APPLICATION NO.	FILING DATE	FIRST NAMED INVENTOR	ATTORNEY DOCKET NO.	CONFIRMATION NO.
10/667,913	09/22/2003	Stefan Deferme	1316N-001664	9924

Office Action Summary

DETAILED ACTION

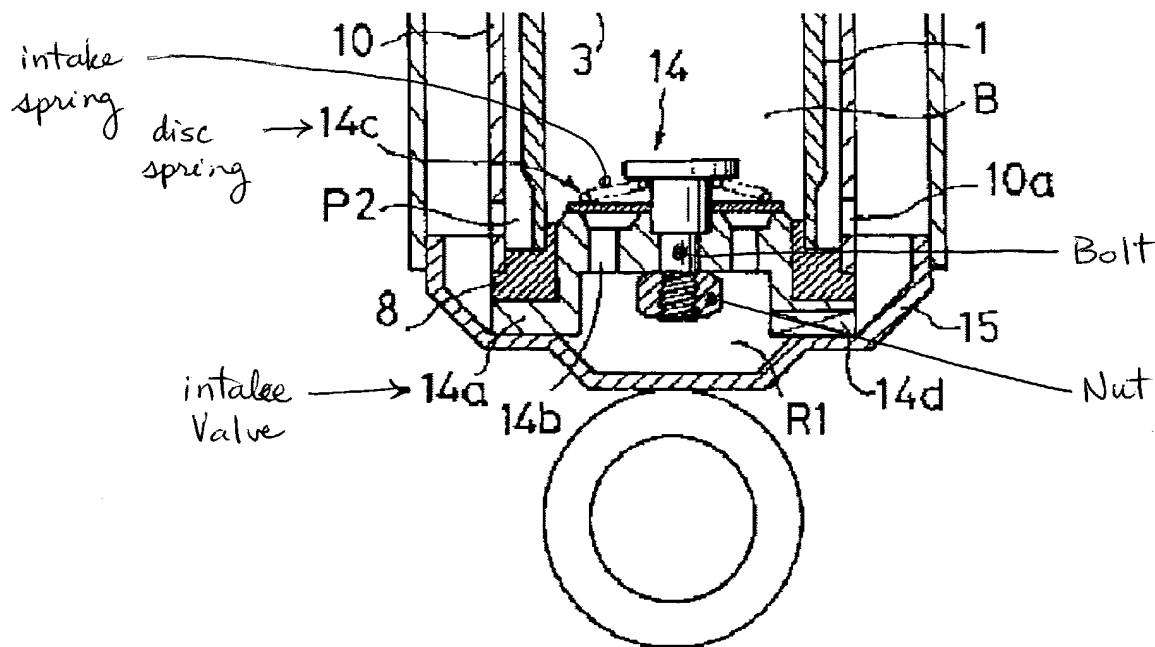
Re: claims 5 and 6, Groves' shock absorber, as rejected in claim 1, shows a one piece intake valve 130 serving as a valve body with passages 132 and valve seat 134 and as a fastening member for intake spring 142 and disc spring 144-152 to securely connecting the intake spring and the disc spring to the valve body; while the instant invention claims a bolt and a nut to fasten the intake spring and the disc spring to the intake valve. Yoshimura et al. teach the concept of using a bolt and a nut to fasten a disc spring 14c and an intake spring to a valve body 14a in a shock absorber. Please see marked up figure below. It would have been obvious to one of ordinary skill in the art at the time the invention was made to have modified Groves' base valve to have comprised a fastening device of a bolt and a nut such as taught by Yoshimura to fasten the intake valve and the disc spring to the intake valve in order to reduce the manufacturing cost when producing a simpler shaped intake valve at the same time increasing the security of fastening the intake spring and the disc spring to the intake valve.
